WILLISTON CONSERVATION COMMISSION
November 20, 2024

Review Stage: Pre-Application

APPLICATION NO: DP 25-04

PROJECT NAME: Marcotte Subdivision

PRIMITIVE TRAILS

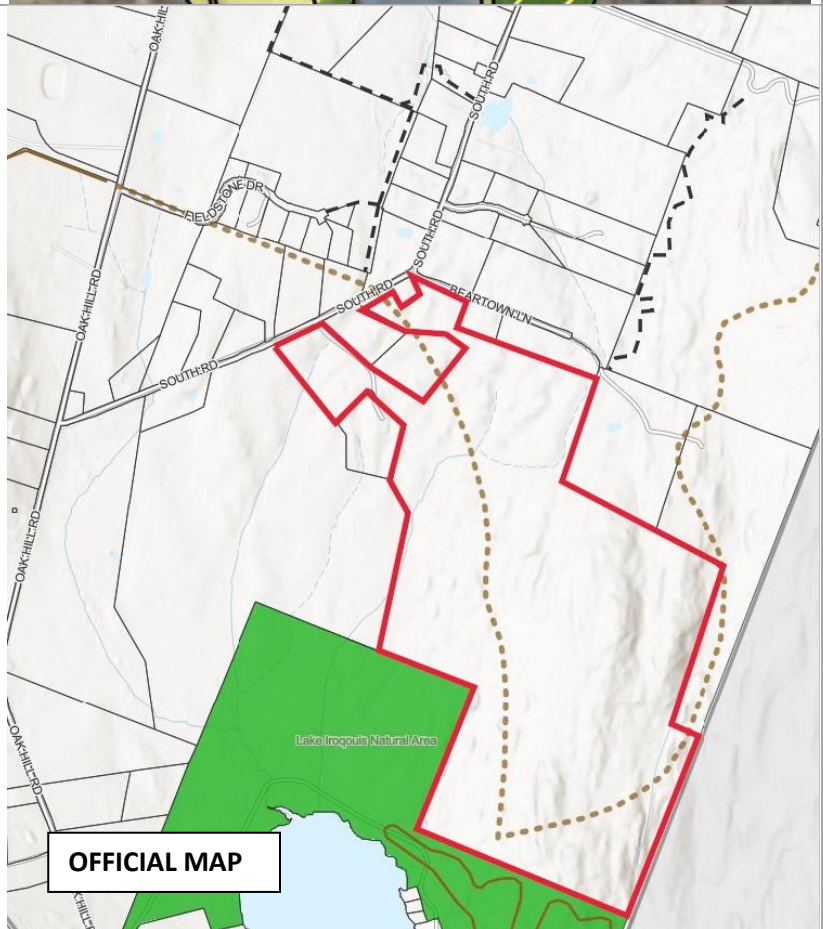
There are two desired primitive trails shown on the property in Map 17 of the Williston Comprehensive Plan and *Williston Official Map* (pictured right). Both sections begin at the Lake Iroquois Recreation District. The desired connection to the west goes northwest to South Road with the intent of connecting to Oak View Hill Trail. The desired connection to the east goes north with the ultimate intent of connecting to the Mud Pond Trails. There are no new trails proposed at this time.

6. The applicant must submit a professionally prepared runoff and erosion control plan as part of the discretionary permit application.
7. The applicant should work with staff and the WCC to explore options to create a trail connection between the Lake Iroquois Recreation District and both South Road and parcels to the northeast.

SIGNIFICANT WILDLIFE HABITAT AREA
WDB 27.5

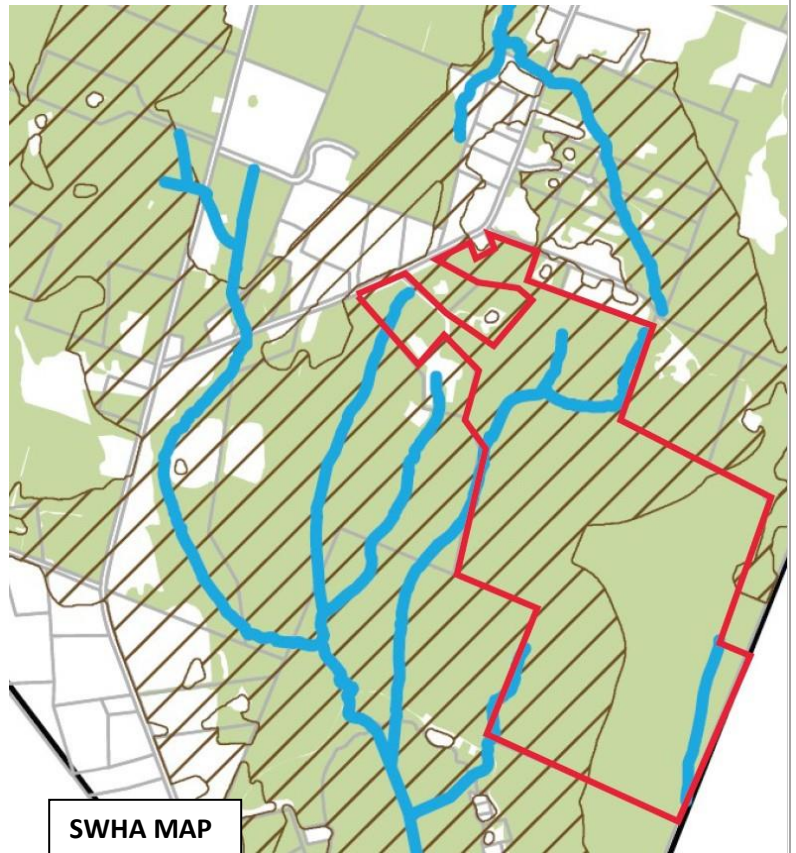
The subject parcel is within a Significant Wildlife Habitat Area (SWHA) due to its designation as both Core Habitat and Wildlife Travel Corridor on the Significant Wildlife Habitat Official Map, adopted as part of WDB 27. WDB 27.5.7 requires that a Habitat Disturbance Assessment (HDA) be prepared by a qualified wildlife biologist and submitted by the applicant as part of a discretionary permit application.

Staff recommends that an HDA be conducted on the northern portion of the parcel where development is proposed. The applicant should contact staff following pre-application review to coordinate an HDA as they can take time to complete.

1. A Habitat Disturbance Assessment (HDA) must be prepared by a qualified wildlife biologist contracted through the Town for the Discretionary Permit application. The HDA should focus on the northern portion of the parcel where development is proposed. The applicant should contact staff following DRB review of the pre-application to discuss procurement of the HDA

UNIQUE NATURAL COMMUNITIES
WDB 27.6

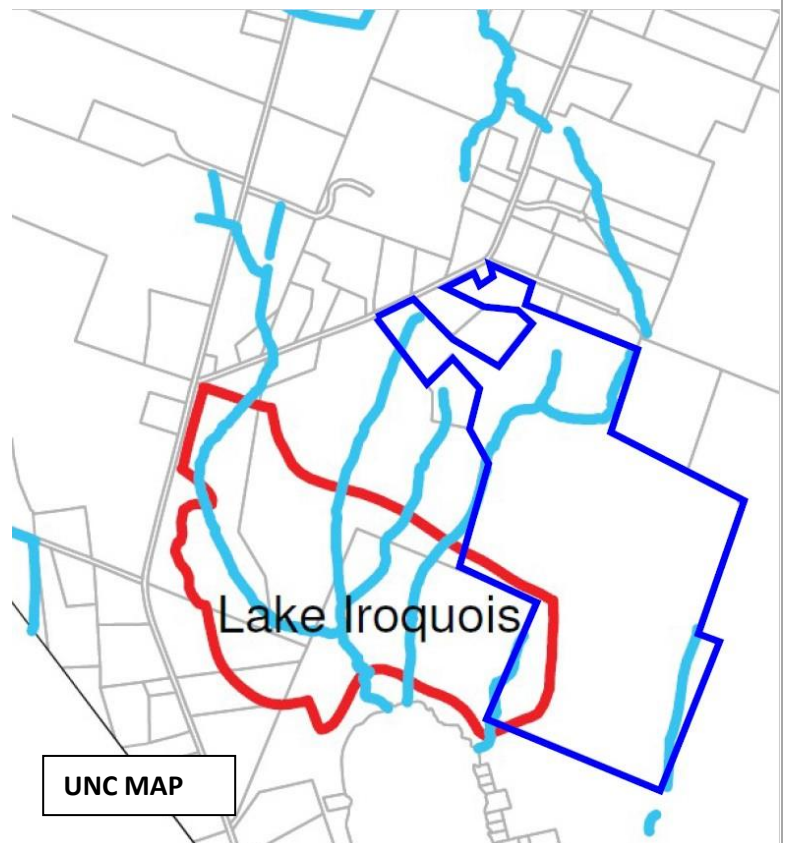
The UNC is mapped near the southwest boundary of the parcel. **None of the proposed development is within or immediately adjacent to the UNC therefore the HDA does not need to assess the mapped UNC area.**

SCENIC VIEWSHED

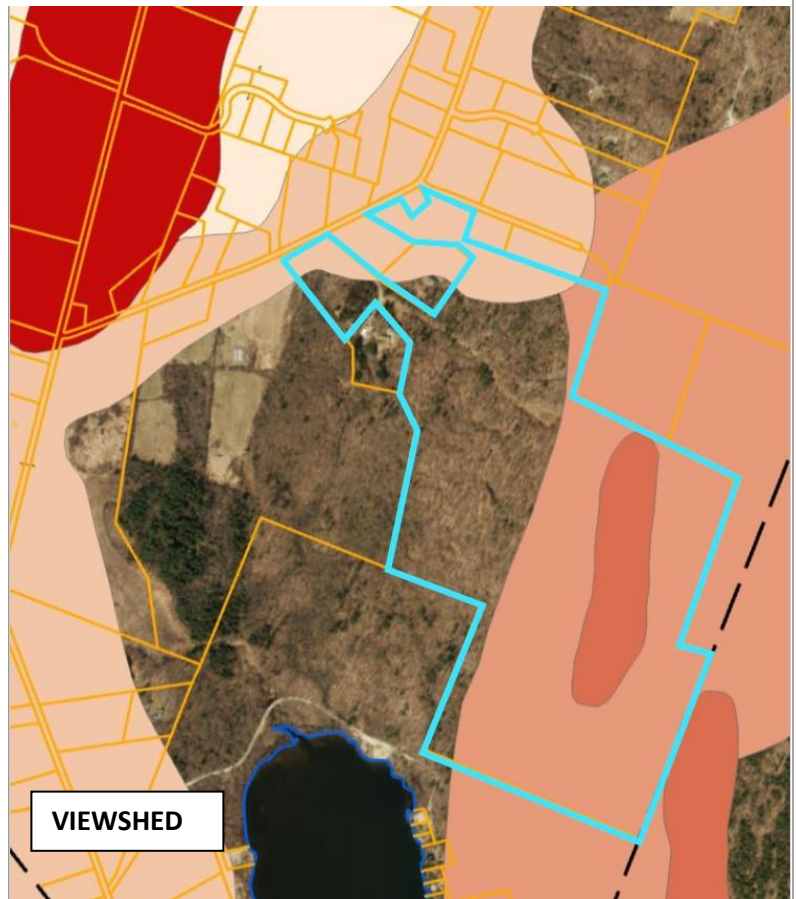
WDB 31.7.2.3 states that landowners who wish to develop parcels including scenic viewsheds will work with the Conservation Commission and DRB to maximize protection of the identified views. Lot 6 is proposed within the Secondary Background/Horizon. Lots 1 and 2 are proposed in the secondary Foreground Viewshed area.

The WCC should discuss potential viewshed impacts from Lots 1, 2, and 6 with the applicant.

WDB 29.8 Wetlands Protection

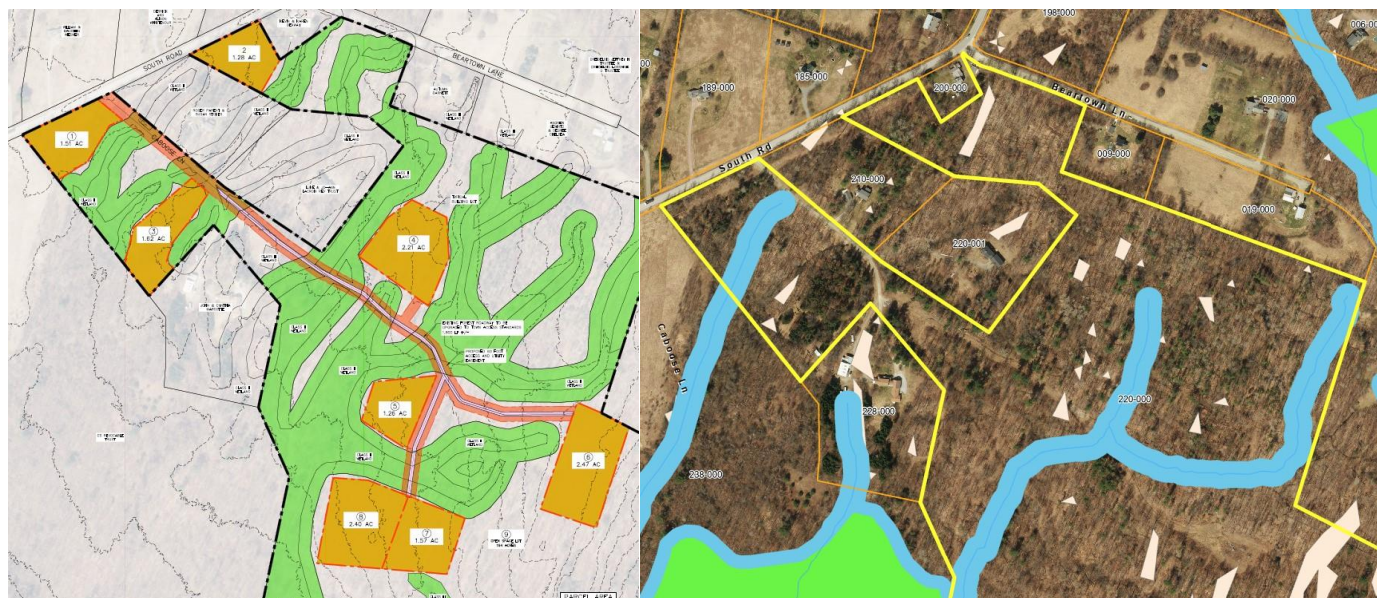
There are Class II, Class III, and two (2) unnamed streams on the subject property. WDB 29.8.1 states that a wetlands delineation prepared by a professional wetlands scientist in accordance with the current guidelines of the Army Corps of Engineers must accompany all applications for discretionary permits for development on sites where wetlands are known or suspected to exist. WDB 29.8.2 states that wetlands must remain in their natural vegetation, but may be crossed by roads, trail, or utility lines where there is no feasible alternative to such a crossing and where all work is conducted in compliance with an approved runoff and erosion control plan and a Conditional Use Permit approved by the Agency of Natural Resources.

4. A wetland delineation for the proposed development must be prepared by a professional wetlands scientist and the site plan submitted with the discretionary permit application shall show wetlands in and within 100ft of the development lots (if present).
